UNITED STATES PATENT AND TRADEMARK OFFICE

Office Action Summary	Application No. 10/582,914	Applicant(s) ITOU ET AL.	
	Examiner PHILLIP GRAY	Art Unit 3767

DETAILED ACTION

Fig. 2

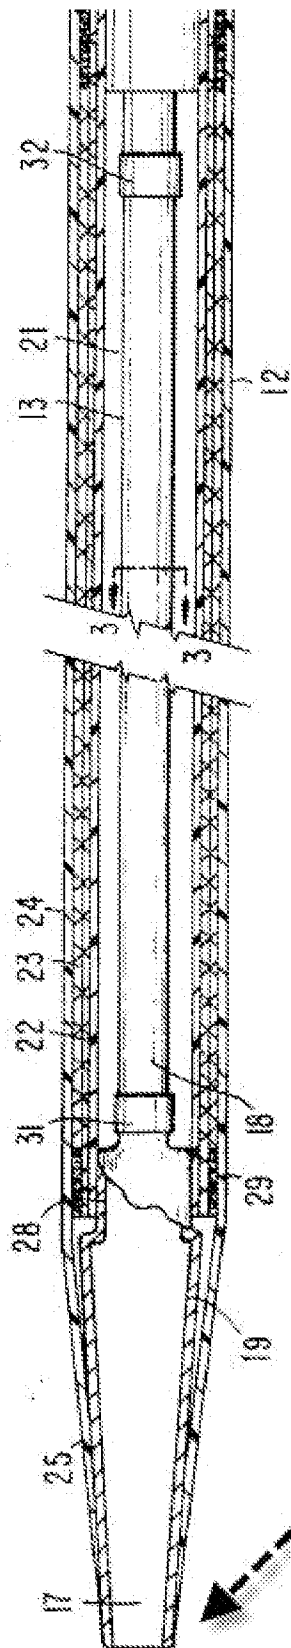
Further see marked up figure 2 of Fina below.

Inner catheter protruding from the
distal end of the outer catheter and
being no more than 10mm

Concerning the newly amended claims 22-27 see rejection above of prior identified structures as in the preceding claims. Concerning claim 22 and the 10mm protruding see figure 1 and further a change in size is generally recognized as being within the level of ordinary skill in the art. In re Rose, 105 USPQ 237 (CCPA 1955). Concerning claim 23, and 26 and the round tip having a length of about 0.5 to 3mm, it is examiner position that the prior art does disclose this however if not it would have been an obvious modification since a change in size is generally recognized as being within the level of ordinary skill in the art. Concerning claim 24 and 27, It is examiners position that the outer catheter of the prior art Cook is continuous and integral, as in figures 1-2. Concerning claim 25 see previous rejection of claimed structures above, as in claim 1 for example.
